Mt. Juliet, Tennessee

Agenda

Thursday, April 16, 2026

Planning Commission

Exhibit B- PMDP PUD w/ Rezone

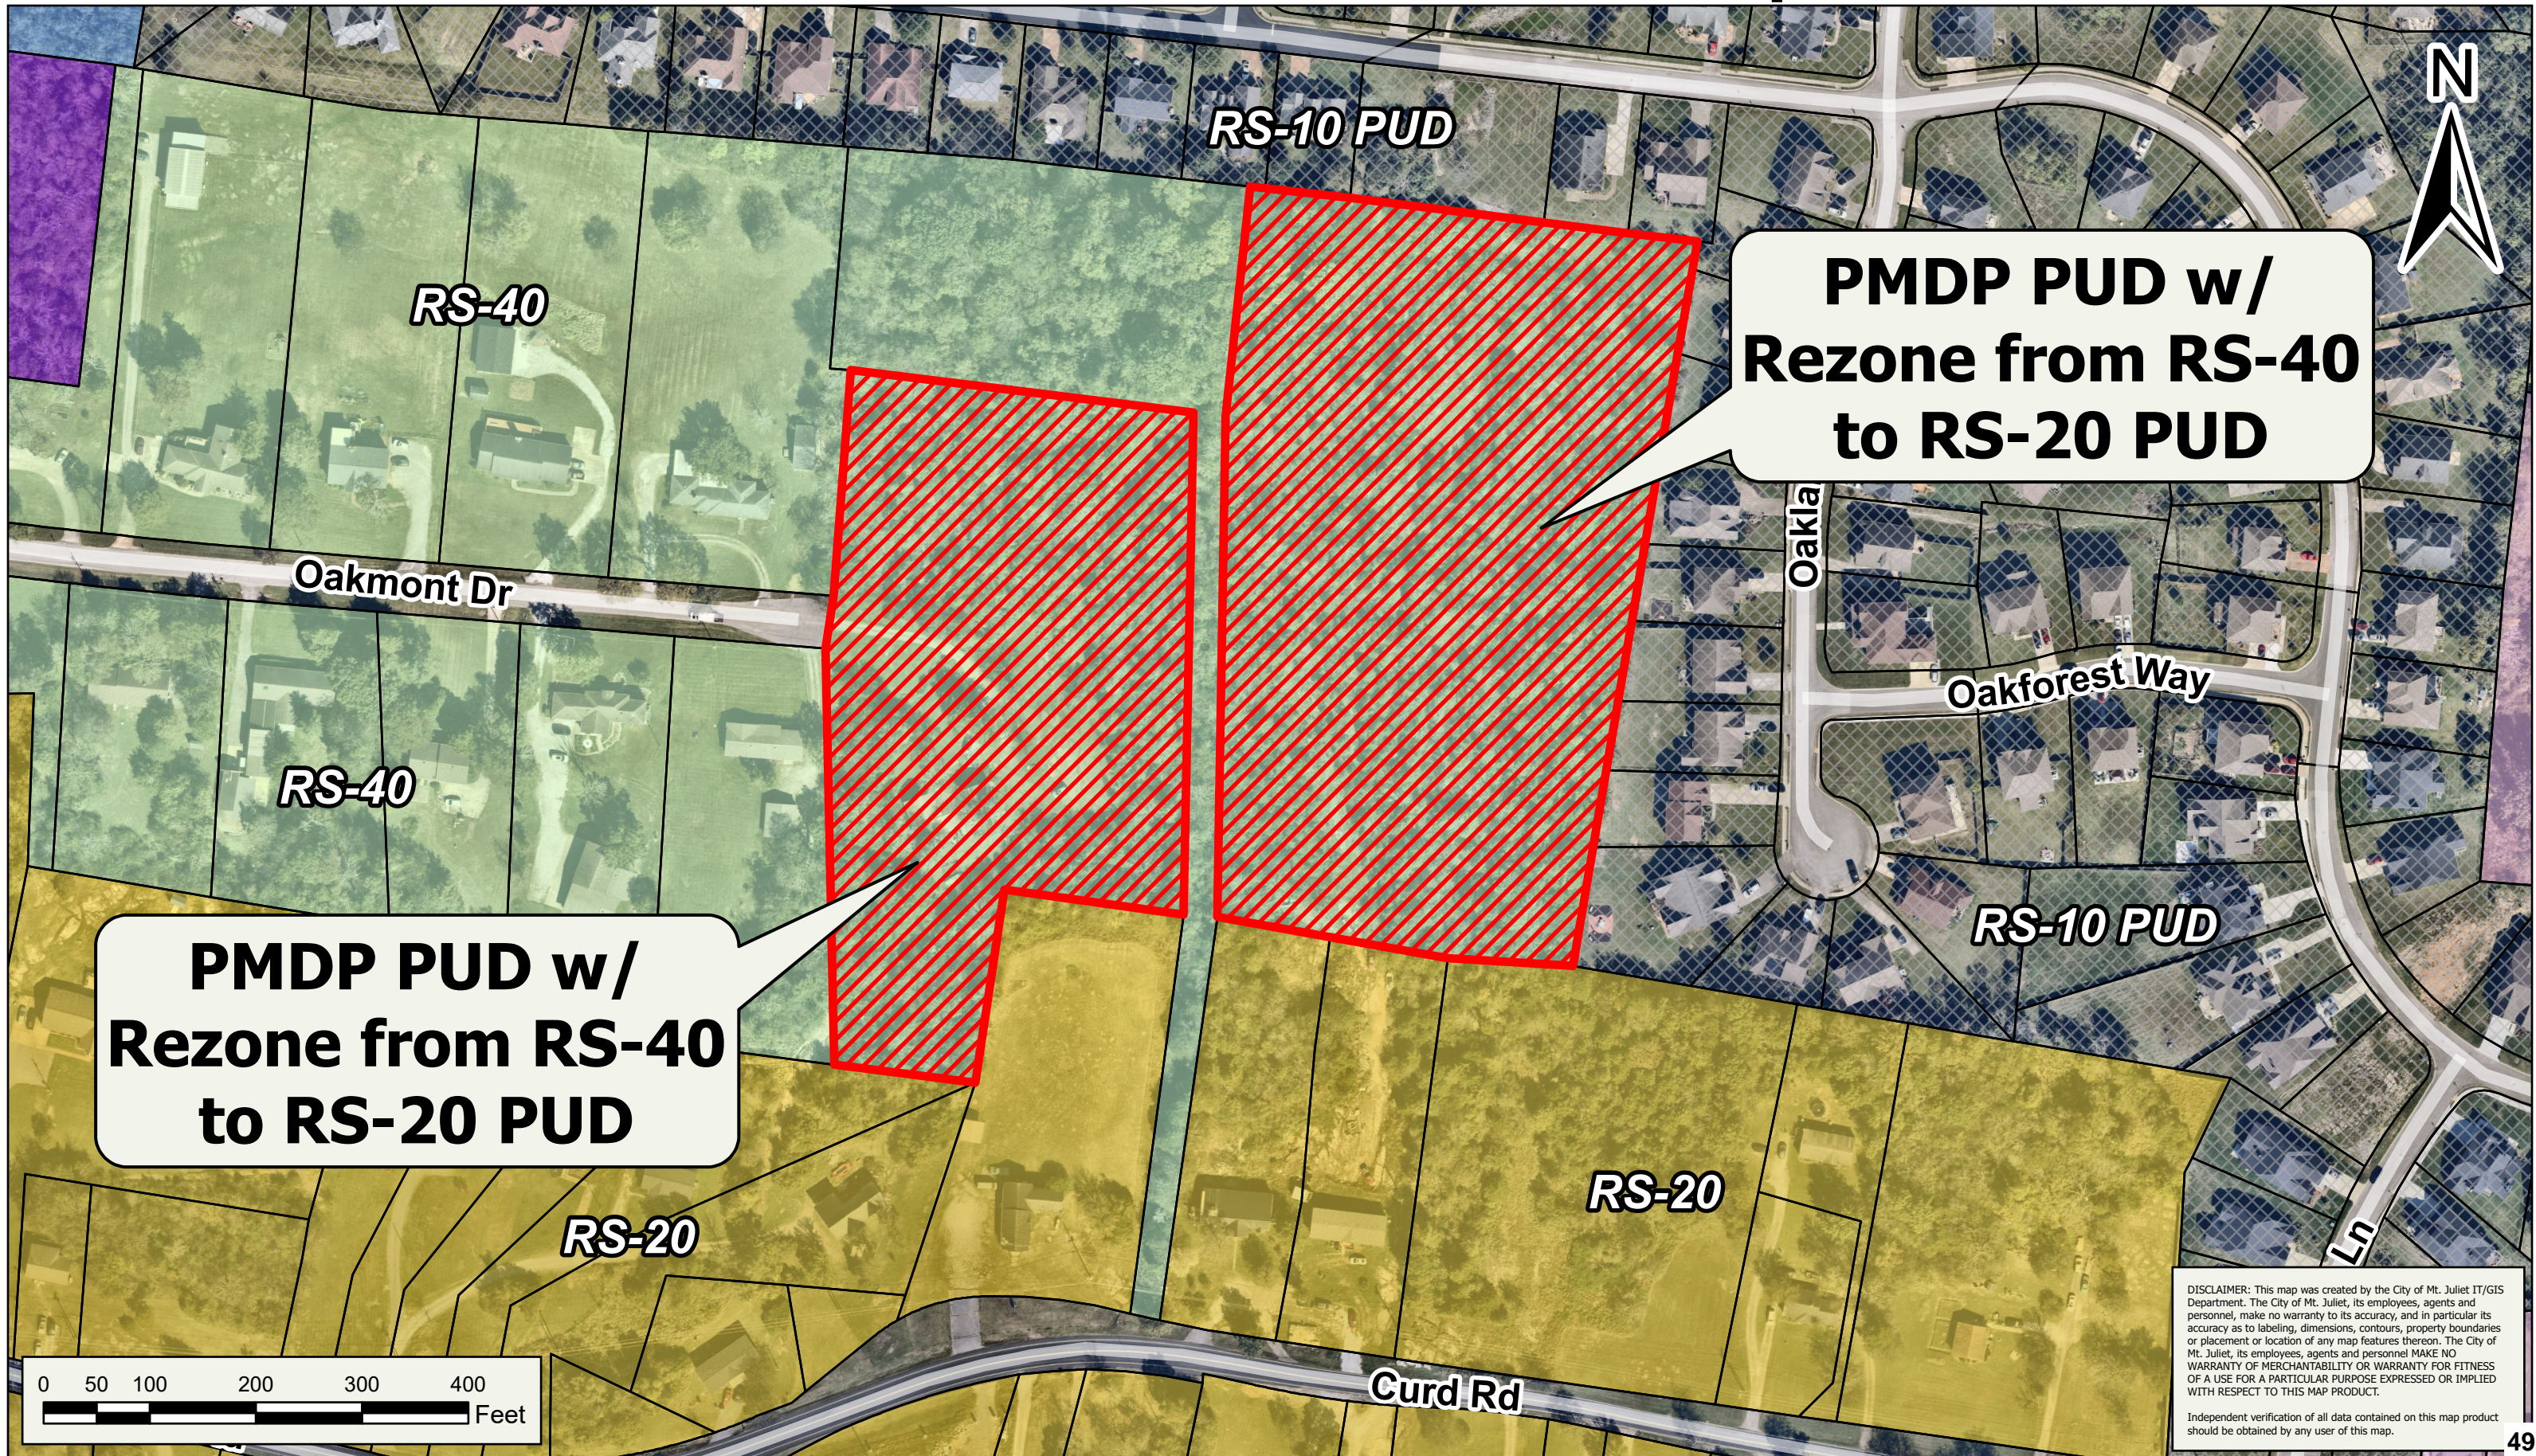
4. The cemetery access easement shall be located in open space and maintained by the HOA. Remove this easement from the residential lots.
5. All detention/retention ponds shall be screened with vegetation. Wet ponds shall include lighted aeration.

6. Preserve as many trees as possible. Provide a tree survey for any vegetation to be used toward buffer requirements.
7. Provide covenants and restrictions to review, if applicable.

8. Provide decorative low maintenance fencing around the cemetery.
9. All fencing shall be low maintenance, decorative materials.
10. Poles and post shall be painted black. Channel posts are not permitted.

13. Should retaining walls be used, they shall be constructed of segmental block.
14. Identify all critical façade lots at final master development plan submittal.

15. A complete landscape plan will be required at final master development plan submittal.
16. Provide formalized elevations to include all materials and percentages at final master development plan submittal.

8. Front loaded homes are not permitted on streets classified as access streets or higher. Side or rear loaded homes are required.
 9. In the event karst features are encountered during grading, a licensed geotechnical engineer shall document the feature, and the feature shall be located by a licensed surveyor. If the feature is to be remediated, the geotechnical engineer shall provide a remediation plan to the City for approval. Efforts will be made to minimize any remediated features within building envelopes.

10. Portions of Lots 103-105 & 207-209 are located within FEMA's Special Flood Hazard Area, Zone A. The City's Floodplain Administrator requests that the building envelopes be revised to be outside this flood zone. If the building envelopes remain in the FEMA Special Flood Hazard Area, all FEMA requirements must be met before a Land Disturbance Permit can be applied for and a Floodplain permit is obtained.

11. Consider consolidating Lots 203 and 204 to create a more viable lot.
 12. Provide aeration if wet ponds are utilized.

13. The driveway to the cemetery shall match the City detail for a residential driveway.
14. Appropriate tapers shall be provided between the existing and the new sections of Oakmont Drive. The tapering shall occur within the existing ROW on Oakmont Drive.
15. Add note that all PUDE's listed outside of the ROW are not the responsibility of the City of Mt. Juliet to maintain.

Exhibit B Land Use Plan Amendment

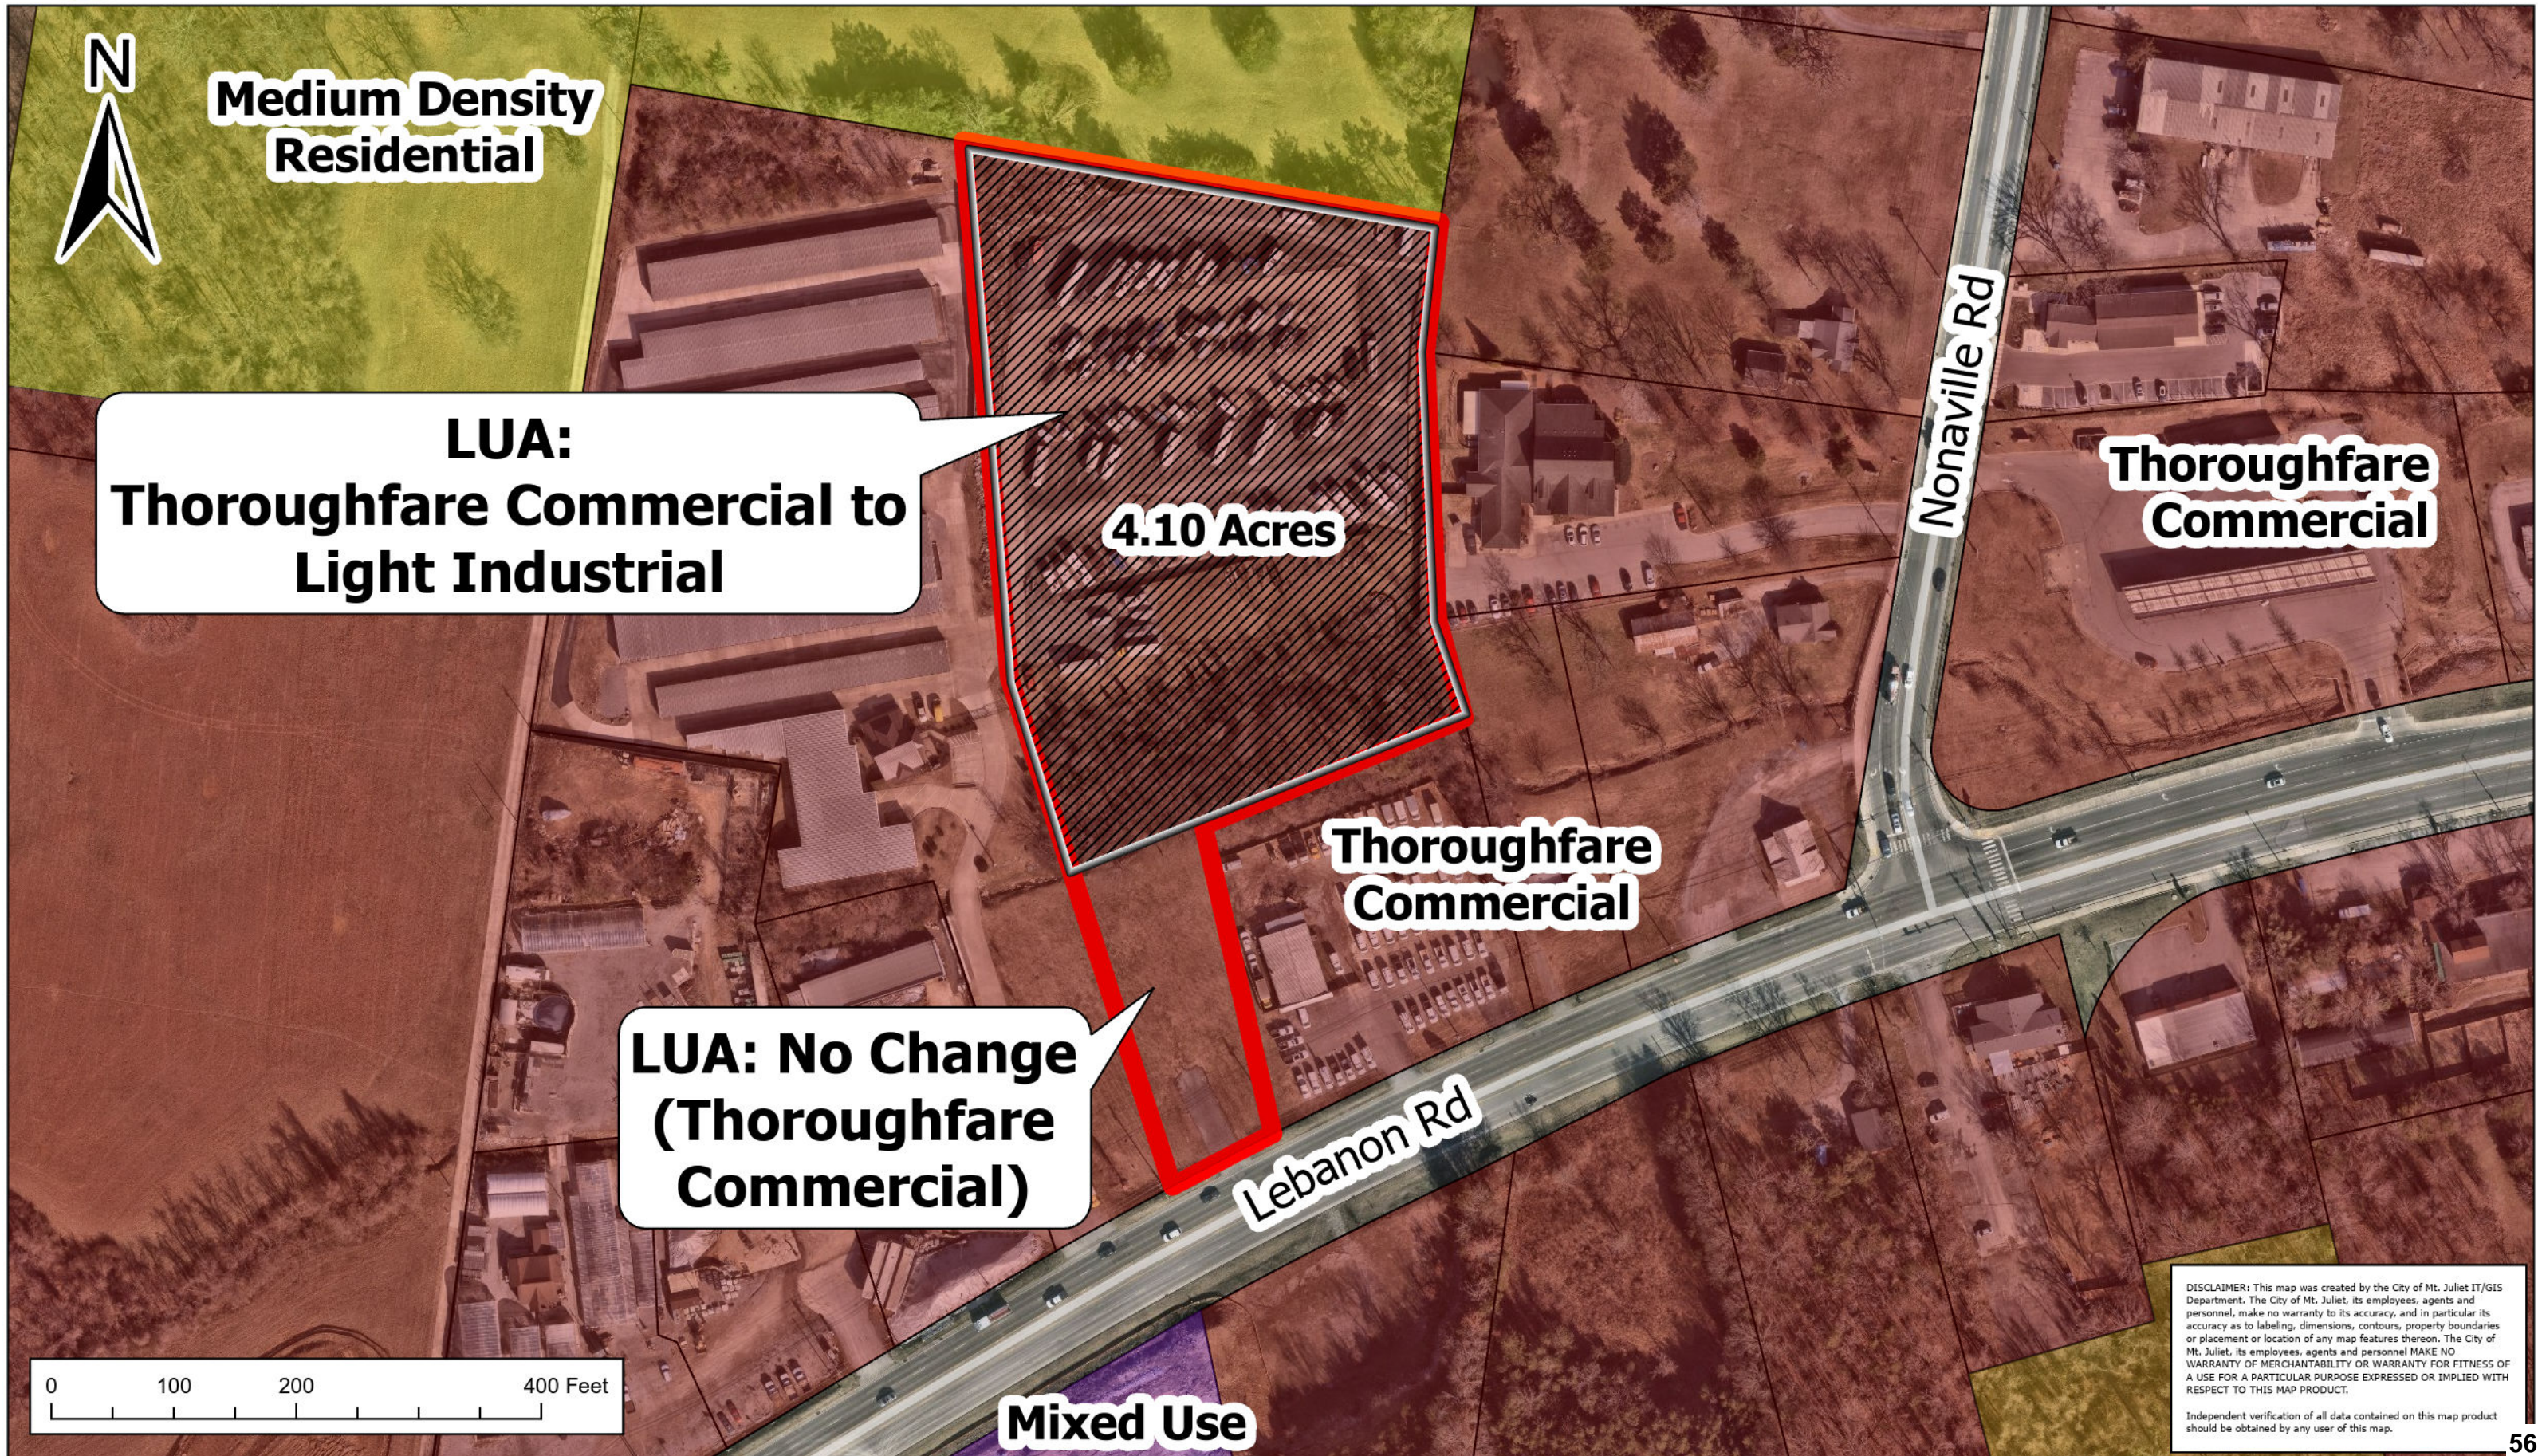
Future Land Use: The City’s future land use map identifies the entire property as Thoroughfare commercial. The future land use map shows the adjacent properties as Thoroughfare commercial to the east, west and south, and medium density residential the north. The land use plan does not support a request for a Business Development Center on this parcel.

Zoning: The zoning on this parcel is CG, Commercial General, along with the existing Lock Box Storage site, which is considered legally non-conforming for self-storage use. The applicant is seeking IR, industrial restrictive, with a PUD overlay for the northern portion of the site, which equates to approximately 4.10 acres, should the land use plan be amended. There would be no change to the southern portion (approx. 0.74 acres) of the lot.

THE PLANS INDICATE A STANDARD 20' REAR SETBACK WITH DRIVE AISLES WITHIN. STAFF SUPPORTS THIS REQUEST IF THE DRIVE AISLES ARE REMOVED FROM THE YARD AND A 20' WIDE TYPE D BUFFER WITH A LOW MAINTENANCE PRIVACY FENCE IS PROVIDED IN LIEU.

Recommendation: The applicant's request for a business development center is not supported by the land use plan; therefore, staff cannot support the request to amend the land use plan. Should the Planning Commission make a positive recommendation to the Board of Commissioners for the land use amendment, rezone and preliminary master development plan, please include the following conditions:
